KMR.CDD.MaQ.1921-1922.01

MUNICIPAL ENGINEER'S OFFICE,
Karachi, 14.2.1922.
15

PLAN SHOWING PROPOSED ADDITIONS & ALTERATIONS TO BE MADE ON EXISTING BUILDING ON PLOT N^o 10

SHEET N^o A.17 MARKET QUARTER.

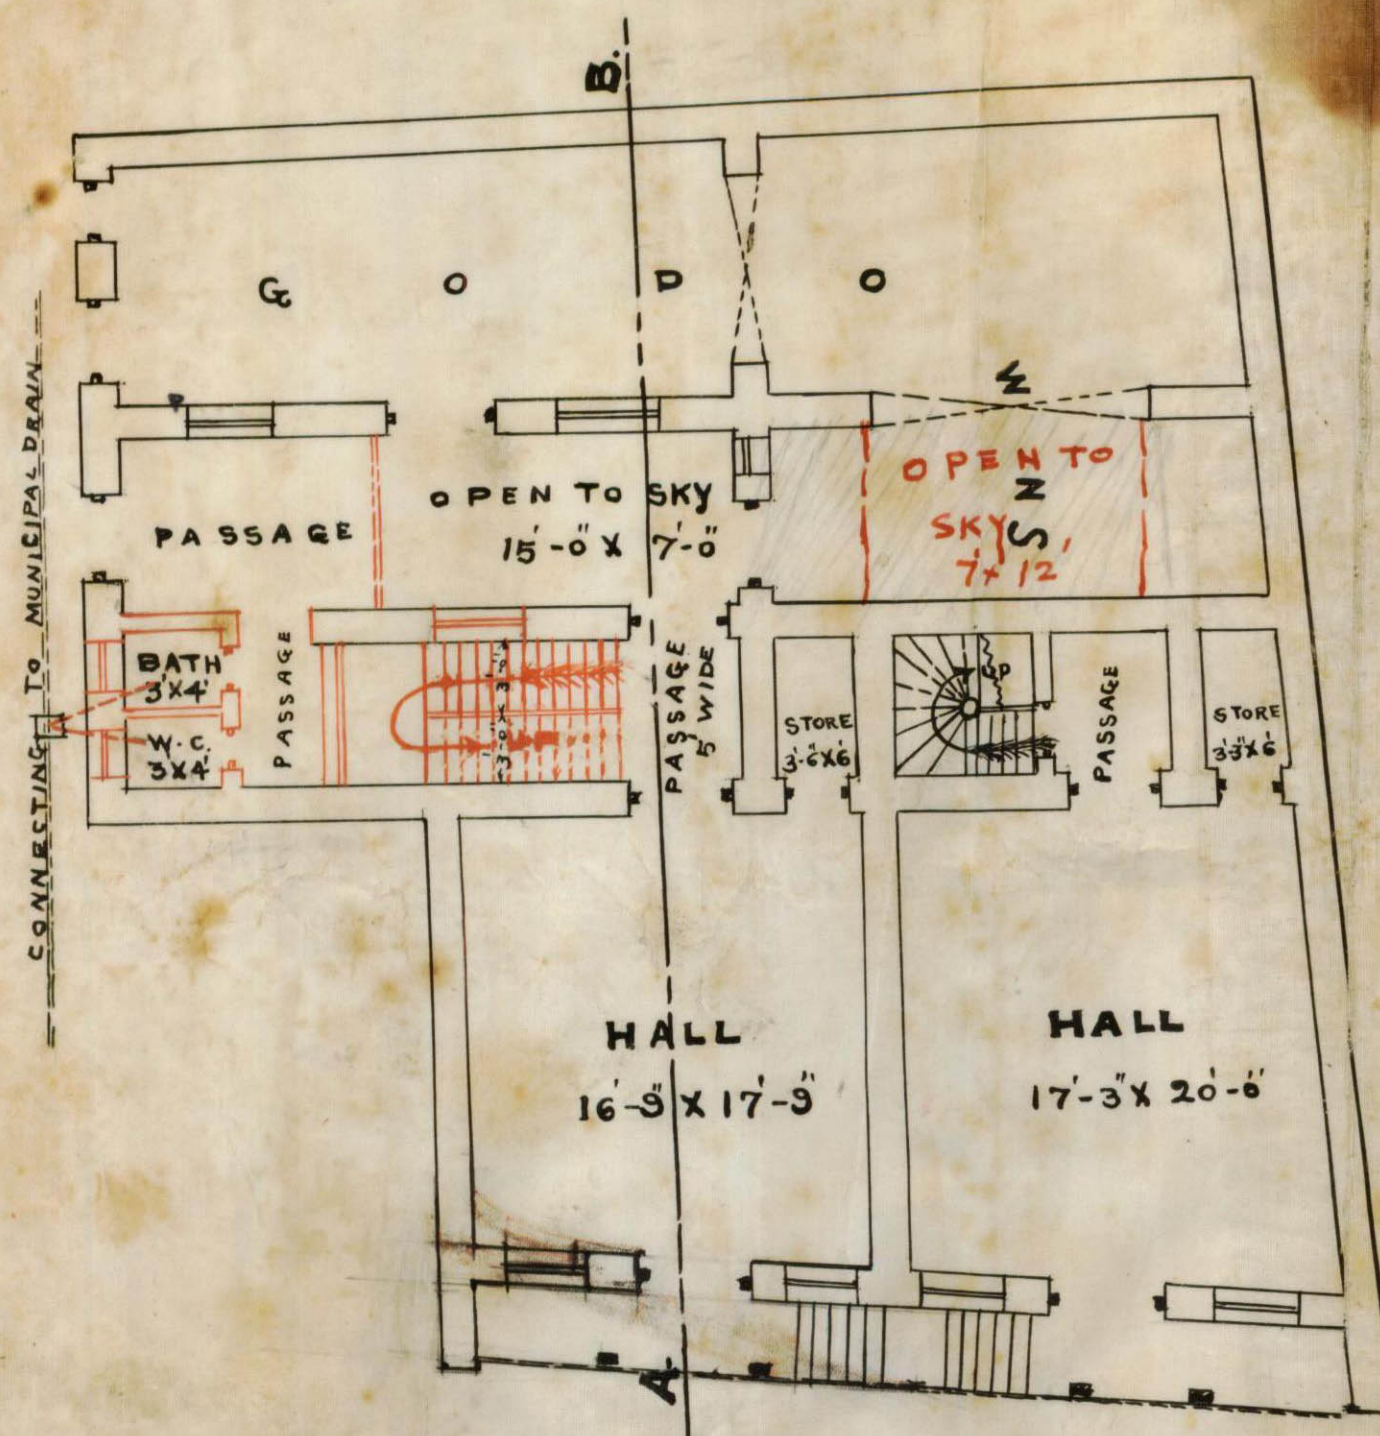
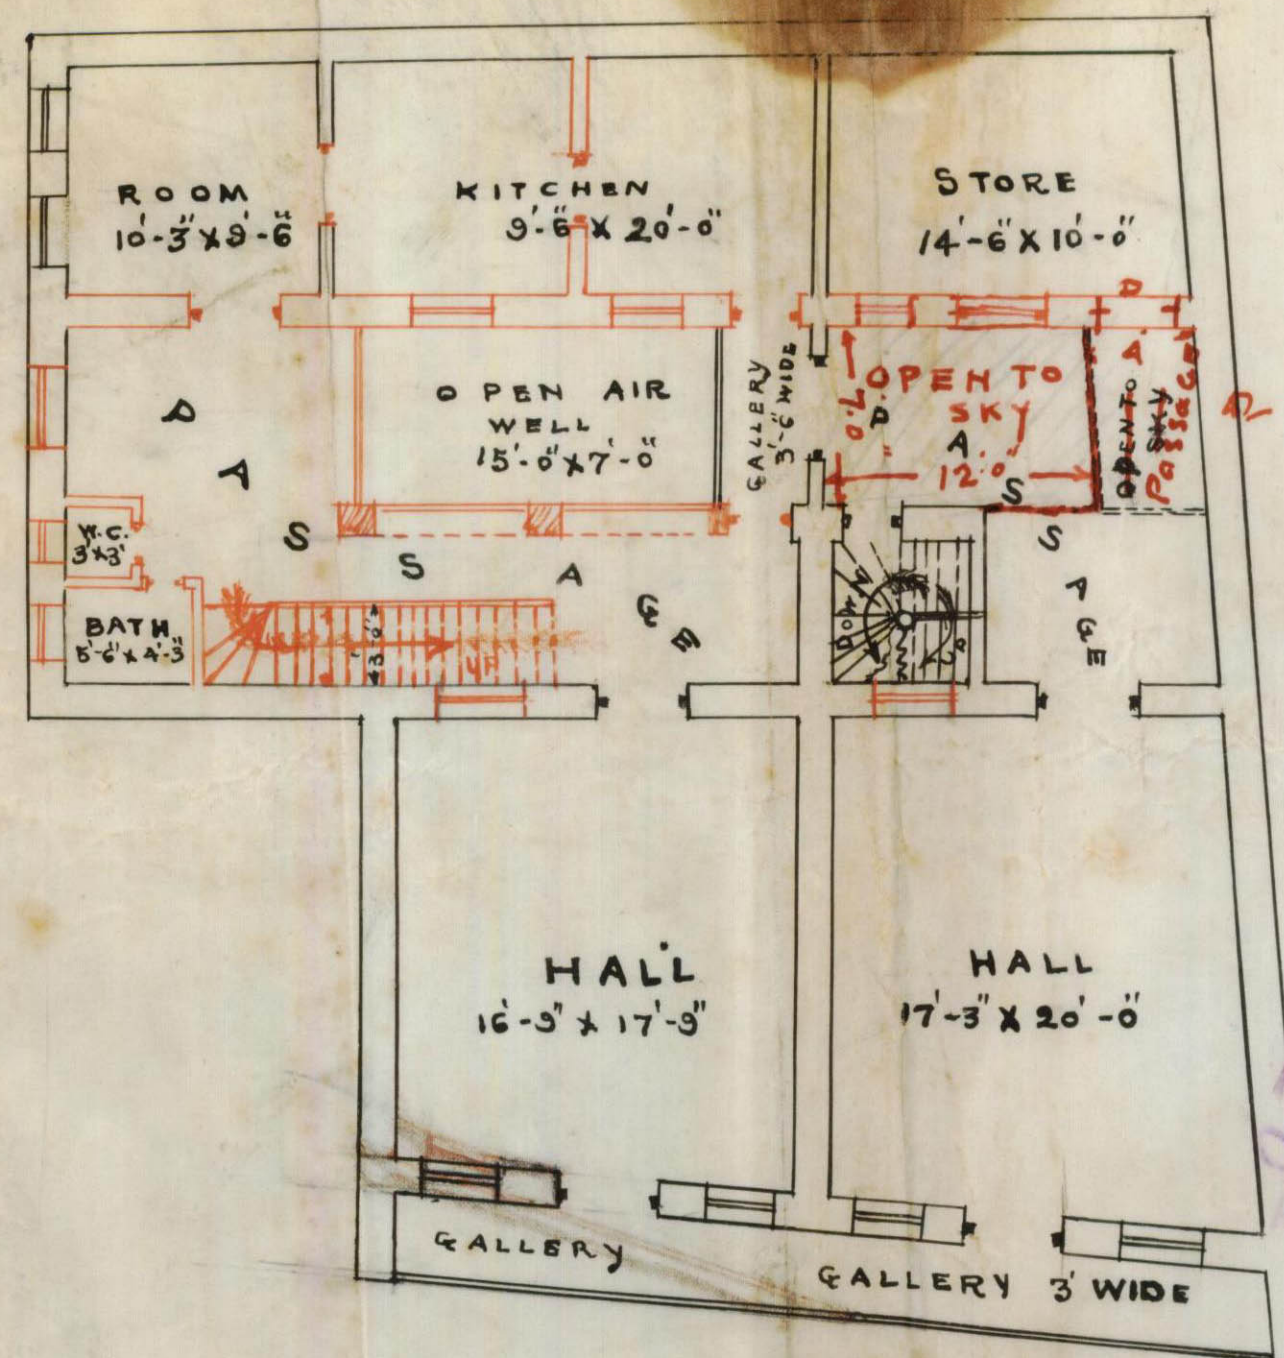
Submitted with report. The owner must open out more open space as shown hatched in pencil to tent to the room properly.

Inform accordingly the building is too confined & requires further ventilation

Submitted with report, that the air well has been opened & there appears no objection to approve the plan.

2ND FLOOR PLAN

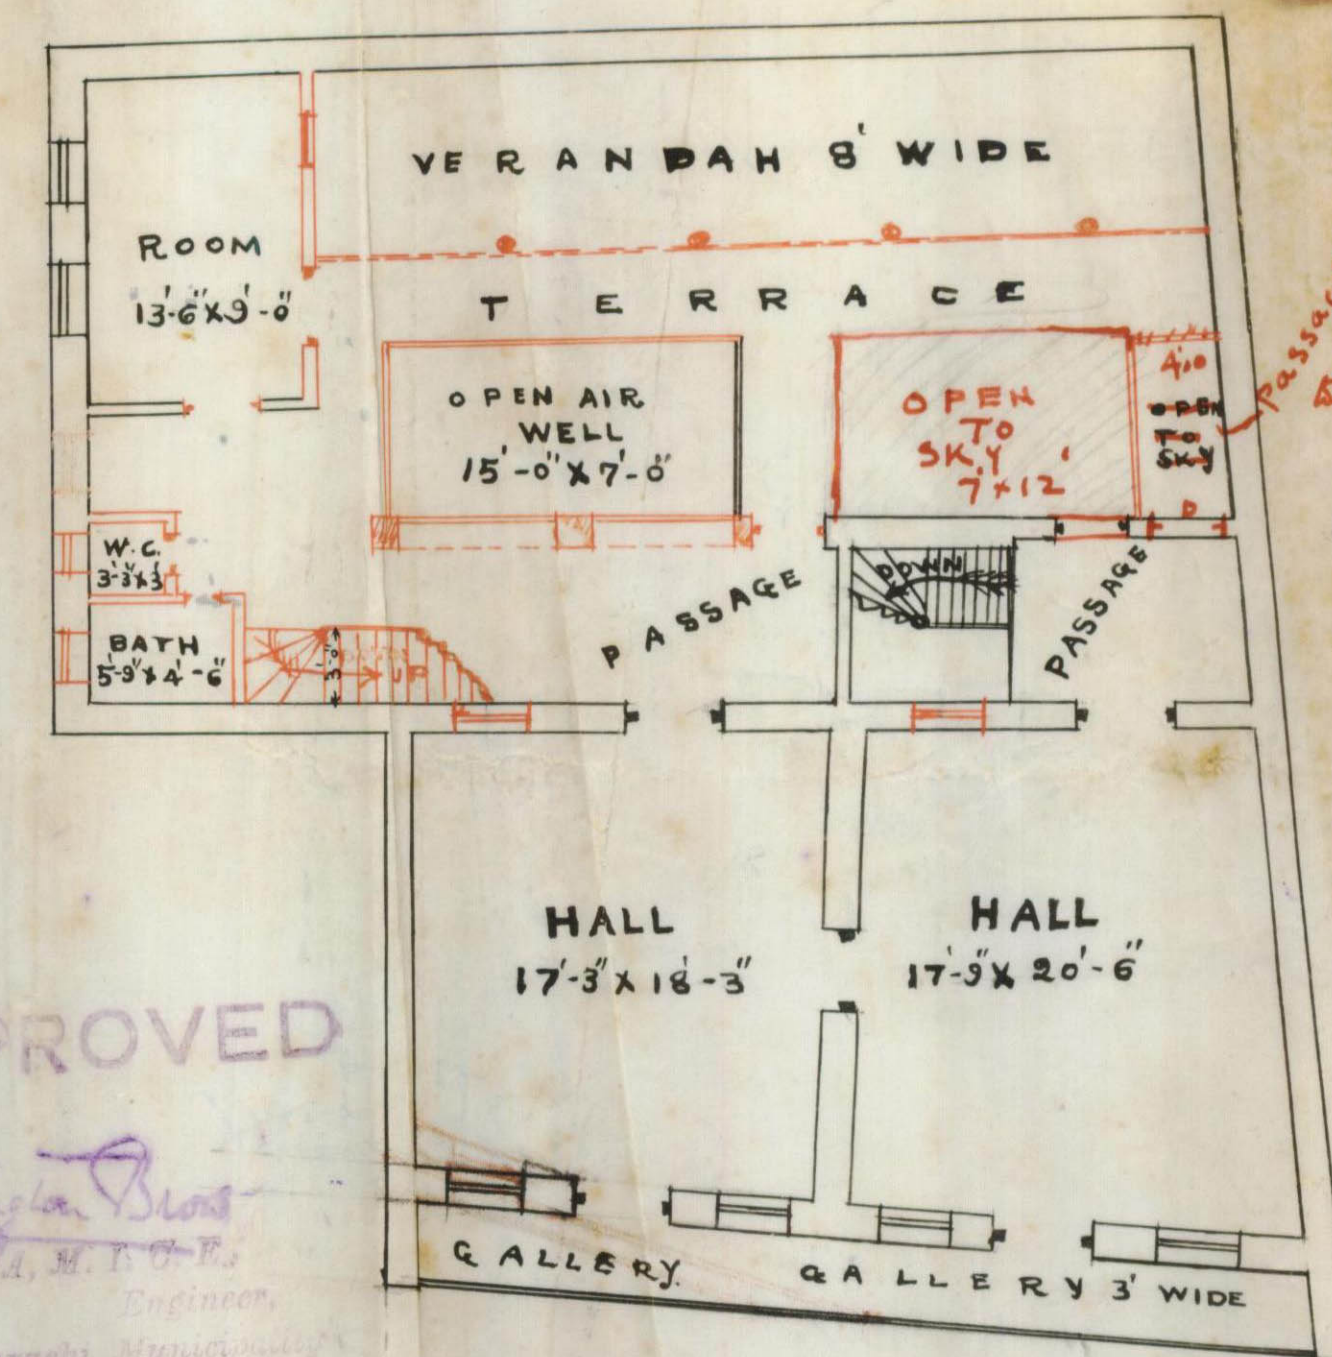
2/ The owner must however set back
 the cabin on the 2nd floor.

In continuation of my letter dated 6th inst I hereby submit an amended plan of proposed additions & alterations on S No 10 Sheet A-17 Market Q^{rs}. I do not at present propose to break my wall and deliver the land coming under alignment as the same will be interfering with the security of the building. I have shifted the proposed cabins on the top floor. You will kindly therefore sanction the plans at an early date.

BLOCK PLAN

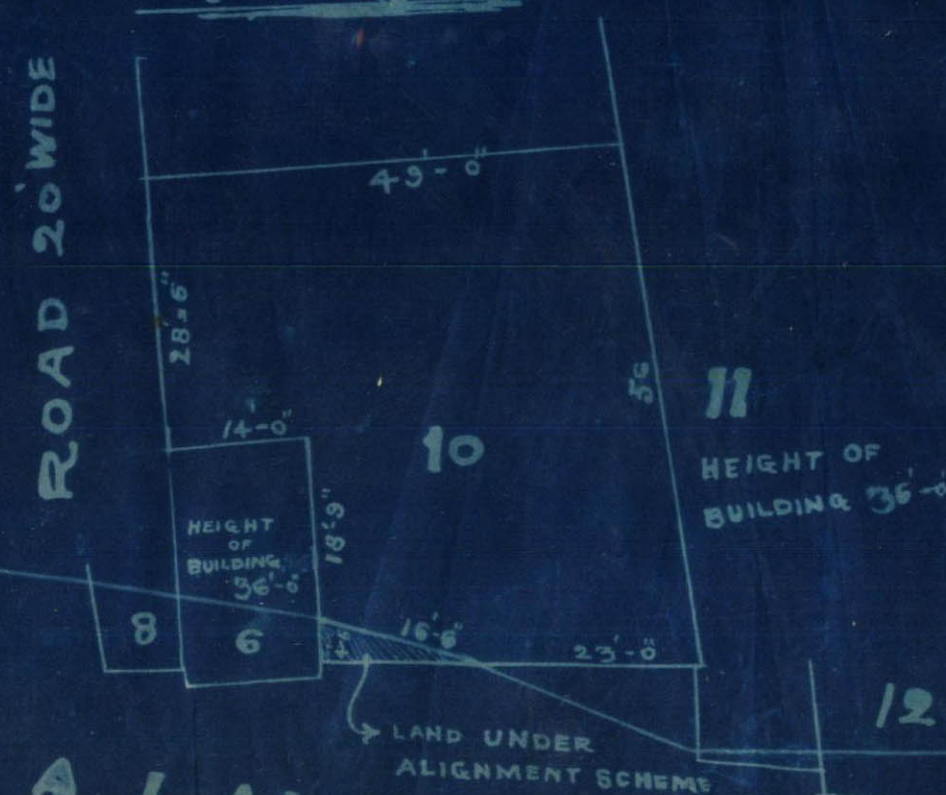
With reference to his letter dated 16th September 1921, Mr. Hiranand Versimal owner of plot No.10, A-17 Market quarter is informed, the building is not shown properly set back on plan in accordance with the sketch of alignment line supplied him.

With reference to the
attached plans submitted
by Mr. Meranda Versinal
for additions and alterations
to building on plot No. 10.
A. 17. I beg to report - Land
measuring about 7 1/2 gds
commencing under acquisition
has been set-back in the
plan. as shown on the
attached sketch coloured
blue.

As regards the Land measuring 1/2 Sq yards available to grant as an alignment coloured red on the attached sketch. orders are therefore requested to enquire from the applicant if he is willing to take up the said Land in exchange.

In Compliance with your memo
no 6319 dated 4th inst - I have the
honour to resubmit herewith an
amended plans of proposed additions
and alterations on S no 10 Sheet A-17
Market Q². And the building has
been shown properly set-back as
shown in the sketch supplied to me
I hope you will sanction this
same at an early date.

SECTION ON A.B.

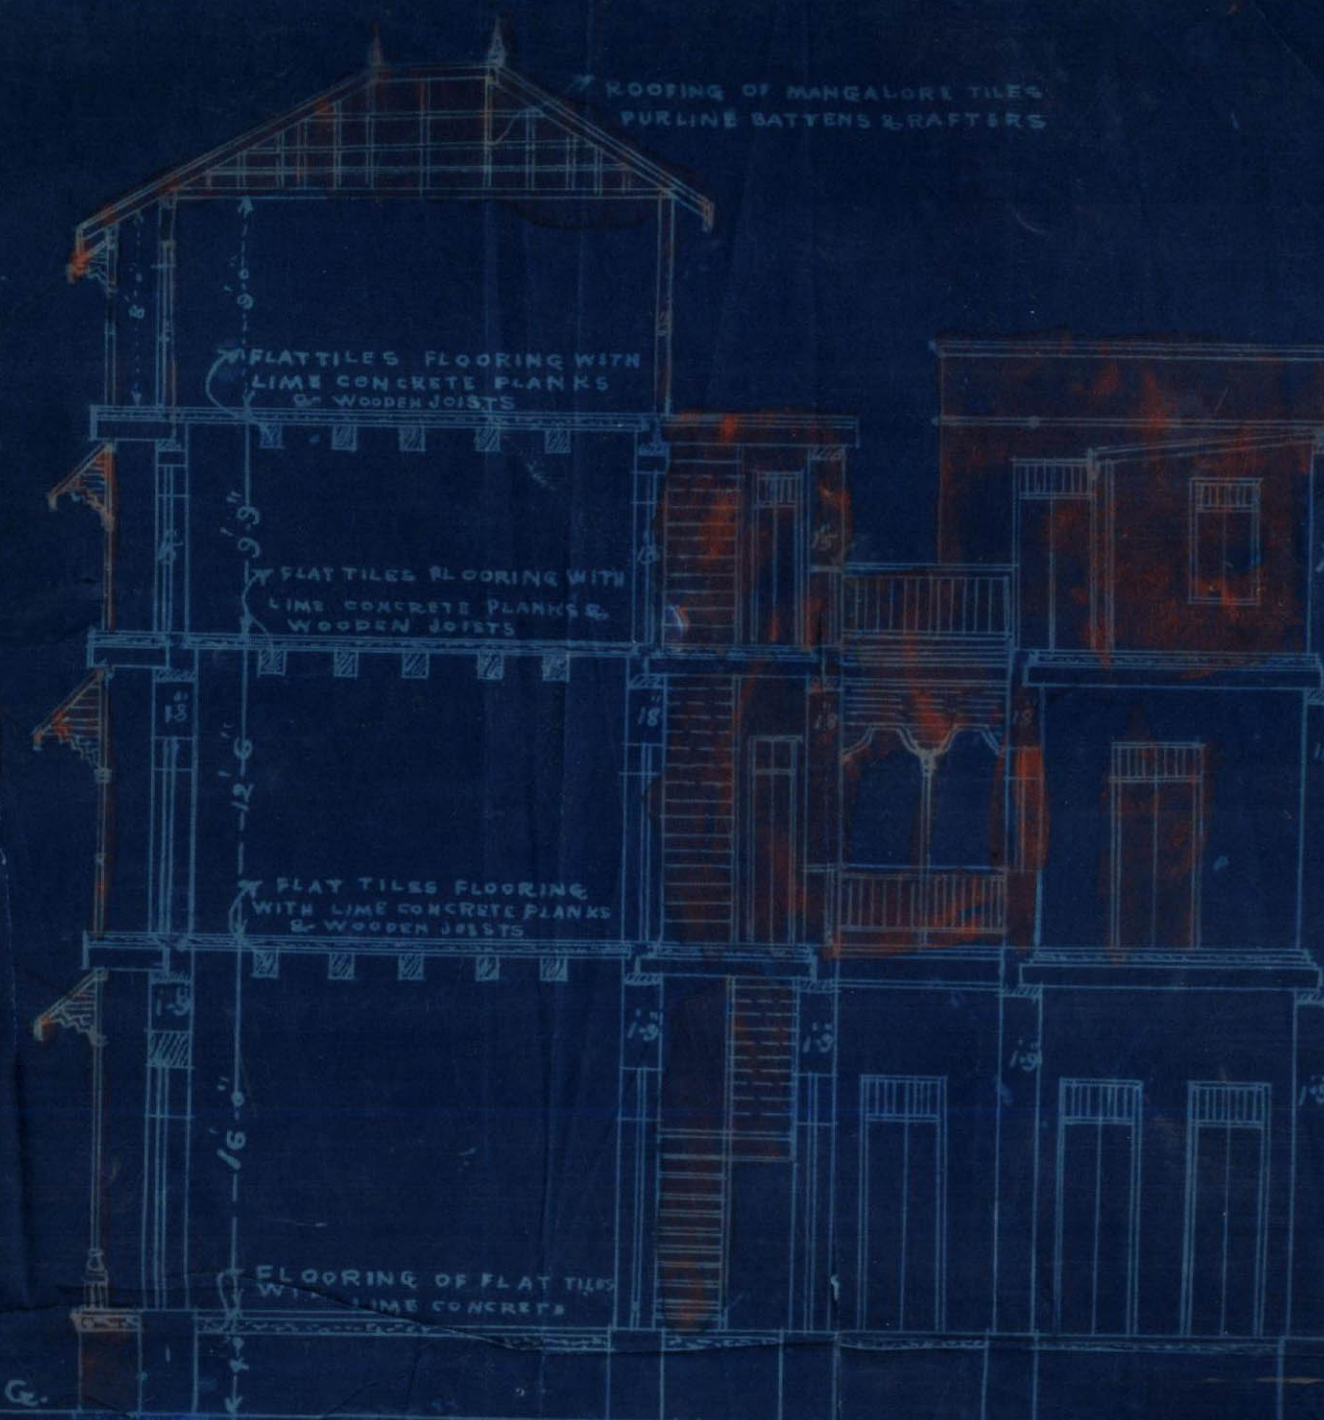
in gallery
Sun shades shown on section
are projecting on h/p land and should be
deleted.

Inform that sunshades should be removed.
